Voltage and resistance measurements for the KWM-2/2A Transceiver are located in the service instructions section of this instruction book.

**SCHEMATIC CHANGES AND EQUIPMENT DIFFERENCES**

KWM-2 and KWM-2A Transceivers, Schematic Diagram  
Figure 7-1 (Sheet A)

KWM-2 and KWM-2A Transceivers, Schematic Diagram  
Figure 7-1 (Sheet B)

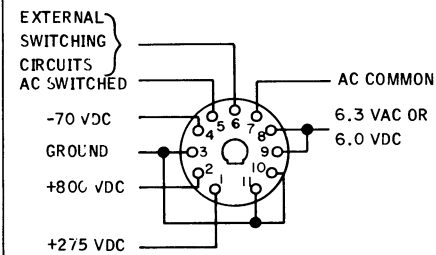
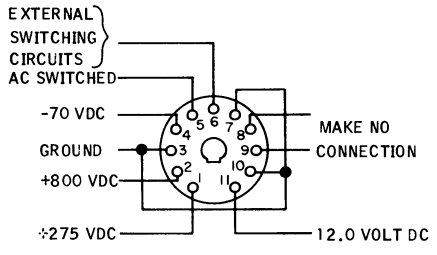
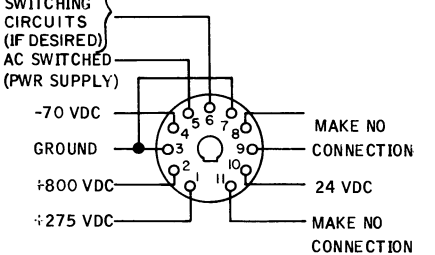
IDENTIFIER	DESCRIPTION
<p>4A</p> <p>5</p> <p>(Cont)</p>	<div data-bbox="324 357 1396 798"> <p><b>BALANCED MODULATOR</b></p> </div> <p>Some early units have a balanced modulator circuit as shown below. If replacing any of these components, recommend replacing with values shown here and in parts list. Incorporating the changes in 5 produces the circuit shown on the schematic. However, these changes are not required and the balanced modulator can remain in the configuration shown below. If the changes in 5 are incorporated, all of change 5 must be incorporated.</p> <div data-bbox="324 1113 1396 1533"> <p><b>BALANCED MODULATOR</b></p> </div> <p>R204 and R205, 220 ohms, added; R203 and R206, 180 ohms, added; R14 and R16, 47 ohms, were 180 ohms; and R15, 250 ohms, was 1 k<math>\Omega</math>. The changes to the balanced modulator circuit shown in 4A produces the circuit shown on the schematic. If these changes have not been made in the unit, recommend the existing configuration be maintained. These changes</p>

*KWM-2 and KWM-2A Transceivers, Schematic Diagram  
Figure 7-1 (Sheet E)*

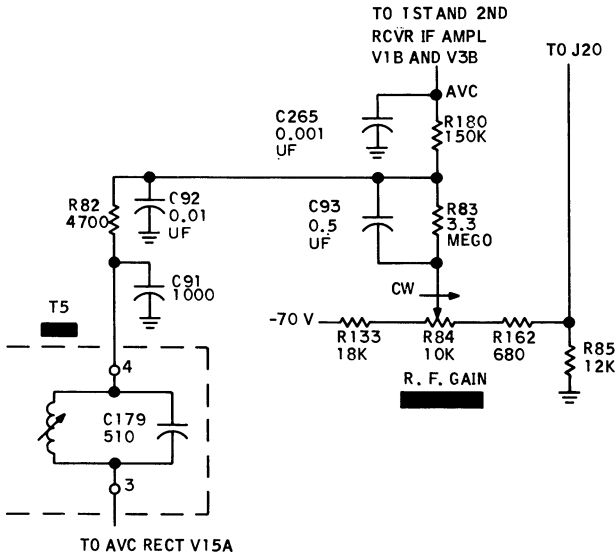
IDENTIFIER	DESCRIPTION
13A	C311, 10 pF, was added. This change eases oscillator adjustment at factory. If this component is not in your unit, do not add it.
13B	CR301, 1N4454, was 1N34A. This change uses a newer, improved diode. Either diode can be used in this application. When stock is depleted, recommend using 1N4454 diodes.
14	R212, 1 megohm, added. This change reduces first transmitter mixer bias in receive operation. If this component is not in the unit, it does not have to be added.
15	C219, 100 pF, was 1000 pF. This change improves decoupling between first transmitter mixer and first receiver mixer. If replacing this component, recommend replacing with 100 pF.
16	R197, 2200 ohms, replaced L3, 2 mH. This change improves decoupling. If the circuit contains L3, it does not have to be replaced with R197. If L3 requires replacement, recommend replacing with R197.
16A	C238, 0.1 $\mu$ F, was 0.01 $\mu$ F. This change improves decoupling. If replacing this component, recommend replacing with 0.1 $\mu$ F.

KWM-2 and KWM-2A Transceivers, Schematic Diagram  
Figure 7-1 (Sheet I)

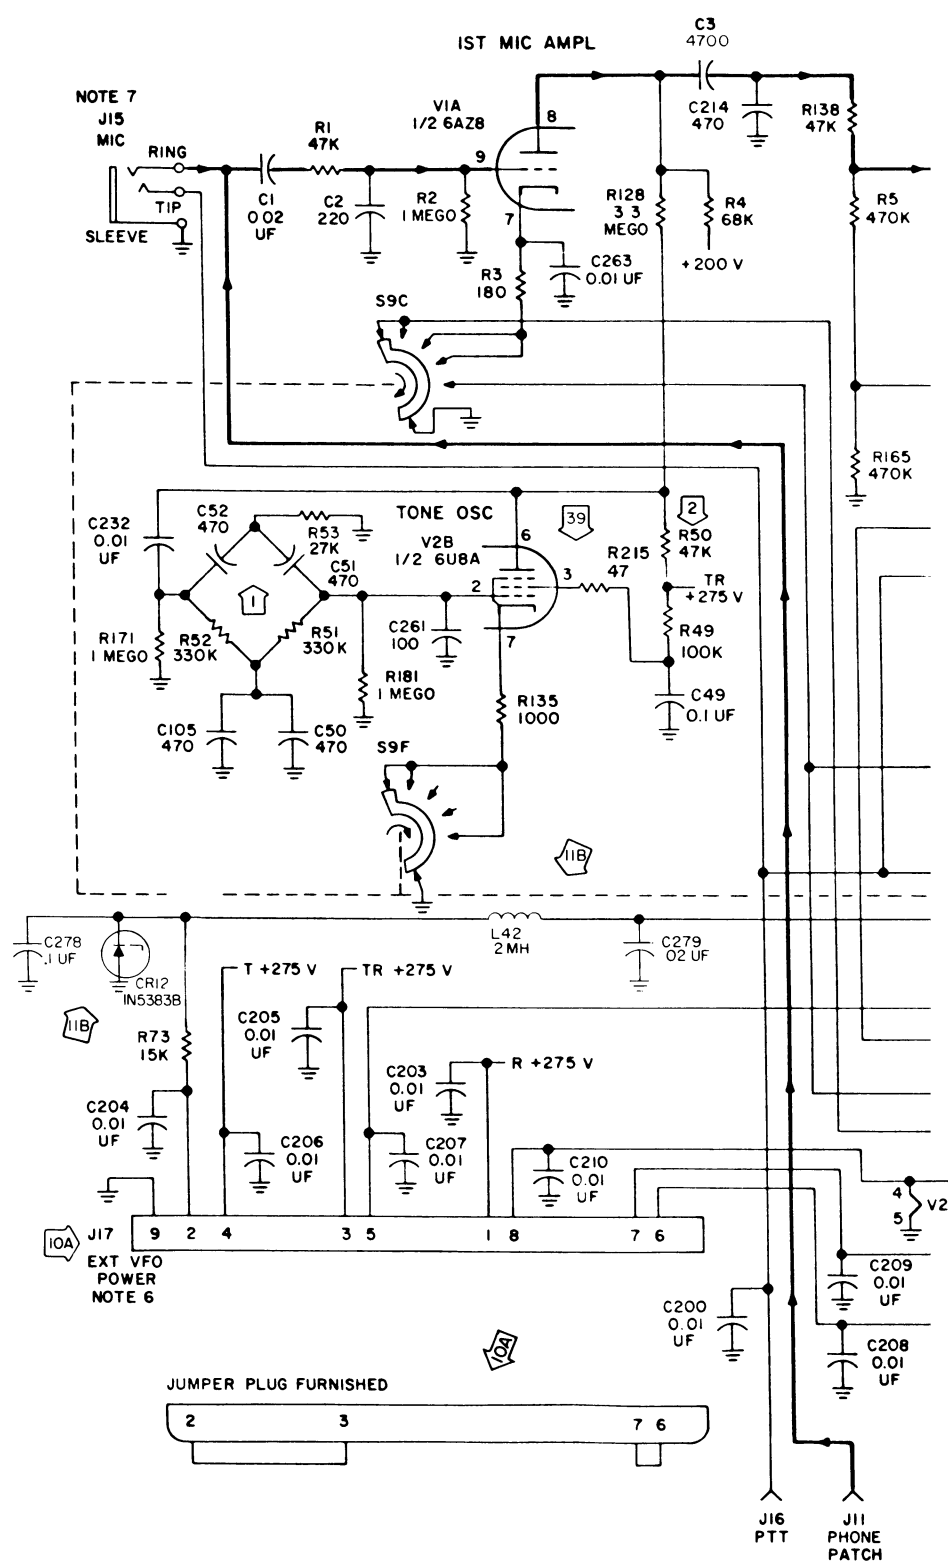
IDENTIFIER	DESCRIPTION
35	R209, 100 ohms, added. This change improves isolation between af output and the antiVOX circuits. If this component is not in the unit, it does not have to be added.
35A	R182, 47 ohms, was 68 ohms. This change was made to prevent af output amplifier from oscillating, effective CI 72196. When replacing R182, recommend replacing with 47-ohm resistor.
36	<p>K2 and K4, enclosed type, were open-telephone type relays. The circuits for the enclosed type are shown on the schematic. The open-telephone relay circuits are shown below for K2 and on the following page for K4. This change reduces relay failure in severe environment. The two types of relays are not interchangeable. If repairing relay K2 or K4 circuits, check the relay type; and if old relays are used, install service bulletin no 7 (reissue).</p> <p>The diagram shows relay K2 with terminals 1 through 14. Terminal 1 is connected to TR +275 V. Terminal 2 is connected to FROM VOX RELAY AMPL V4B. Terminal 3 is connected to RCVR CKTS DISABLE. Terminal 4 is connected to -70 V. Terminal 5 is connected to XMTR CKTS DISABLE. Terminal 6 is connected to -70 V. Terminal 7 is connected to ground. Terminal 8 is connected to ground. Terminal 9 is connected to TO RCVR-XMTR RF AMPL V7. Terminal 10 is connected to ground. Terminal 11 is connected to ground. Terminal 12 is connected to TO T6-BLK. Terminal 13 is connected to ground. Terminal 14 is connected to R167 (100) which is connected to TO K3-2. There is also a connection from terminal 14 to TO K3-5. A component J2 (RCVR ANT) is connected to terminal 9 and ground.</p>

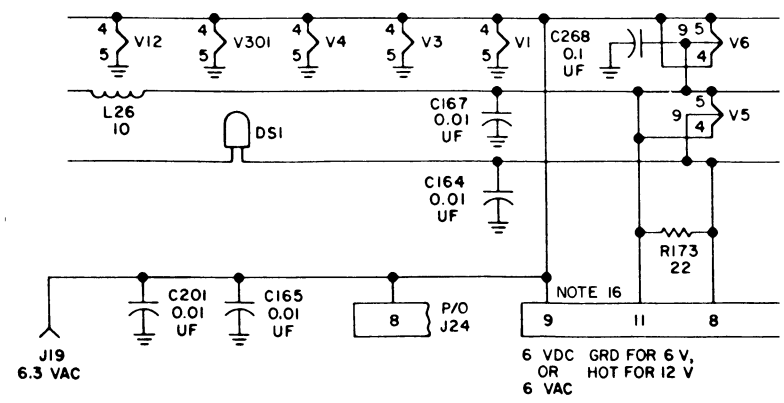
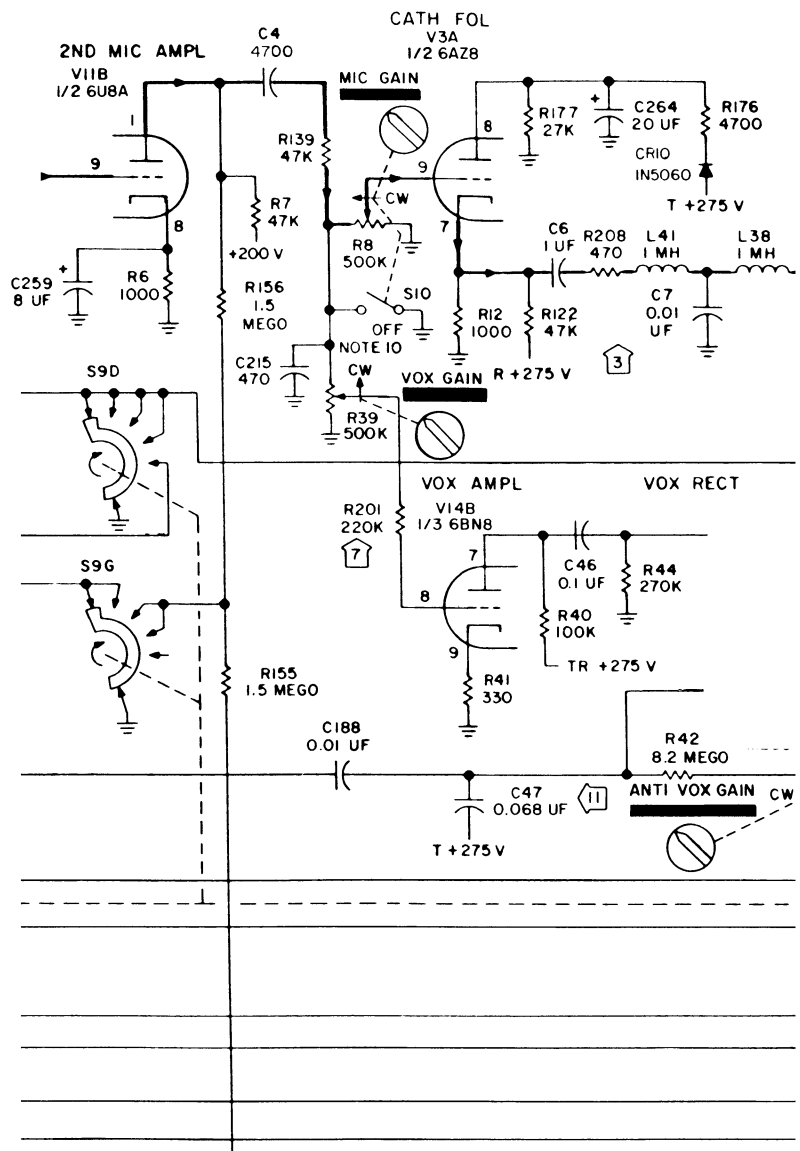
None	Schematic corrections; R170, 100 kΩ, was R70, 100 kΩ; V8-3 was V8-8; and V8-8 was V8-3.
36A	Ungrounded receive antenna shield at K2-9. This change eliminates oscillations on the receive antenna line when the KWM-2/2A is operated around 28 MHz. If your unit is operated around the above frequency and you encounter the oscillations, unground the shield at the K2-9 end of the receive antenna line. If this problem does not pertain to your unit, do not make the change.
36B	C227, 0.01 μF, was added. This change provides a high-frequency bypass and eliminates ultrasonic oscillations that cause increased noise and audio distortion. If this component is not in your unit, it is recommended that you add it.
36 (Cont)	Refer to 36 above for a description of the change in K4 relay from open telephone (shown on next page) to enclosed (shown on the schematic).

*KWM-2 and KWM-2A Transceivers, Schematic Diagram  
Figure 7-1 (Sheet J)*

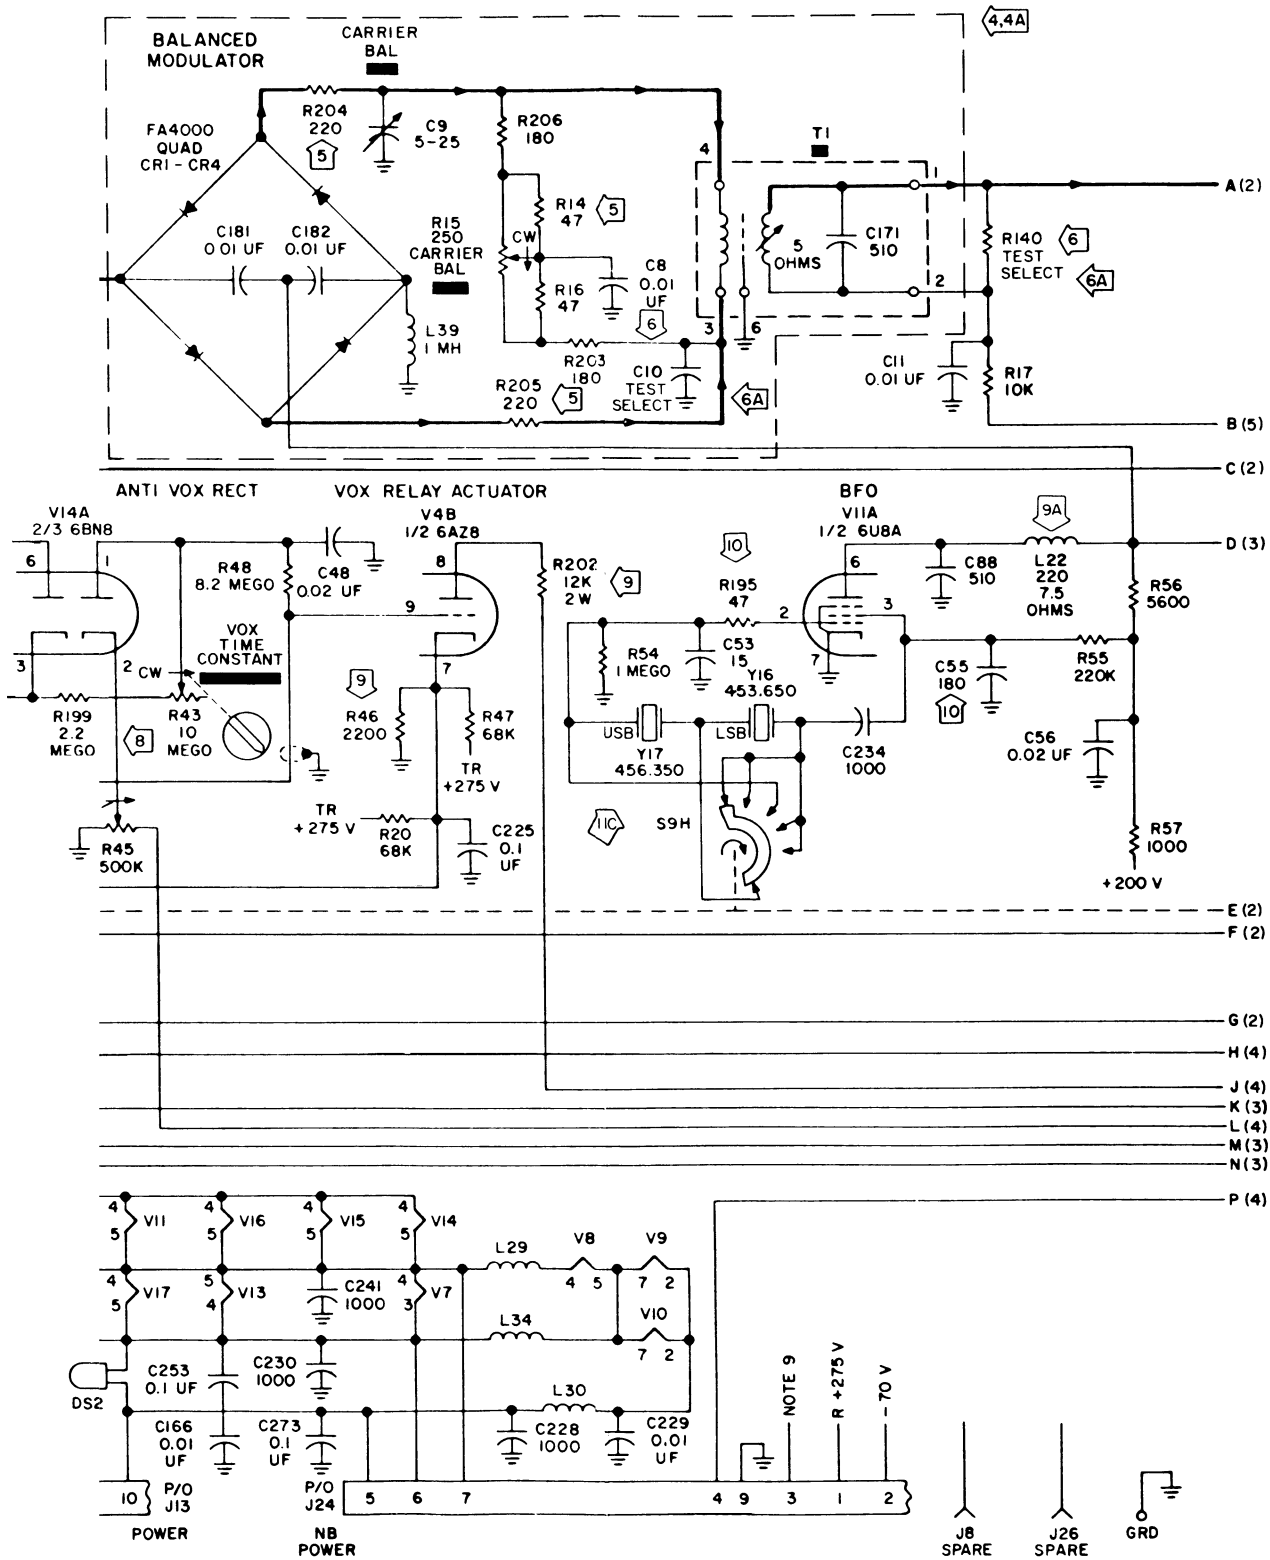
IDENTIFIER	DESCRIPTION
<p>36 (Cont)</p>	
<p>36C</p>	<p>Corrected schematic diagram error. Connector J26 was inadvertently called J28.</p>
<p>37</p>	<p>R211, 470 ohms, added and R190, 1500 ohms, was 2200 ohms. These changes shift the ALC line bias to reduce transmit gain variations between LSB, USB, and CW positions versus TUNE and LOCK positions of the EMISSION control. If repairing this circuit, recommend that same configuration be maintained.</p>
<p>None</p>	<p>Restated all notes.</p>
<p>38</p>	<p>C155, 63- to 320 pF variable capacitor, was 15- to 120-pF variable capacitor. This change improves pa output loading on 15- and 10-meter bands. If replacing this component, recommend replacing with 63- to 320-pF variable capacitor.</p>
<p>39</p>	<p>R215, 47 ohms, is added in series with the screen grid of tone oscillator V2B to act as a parasitic suppressor.</p>
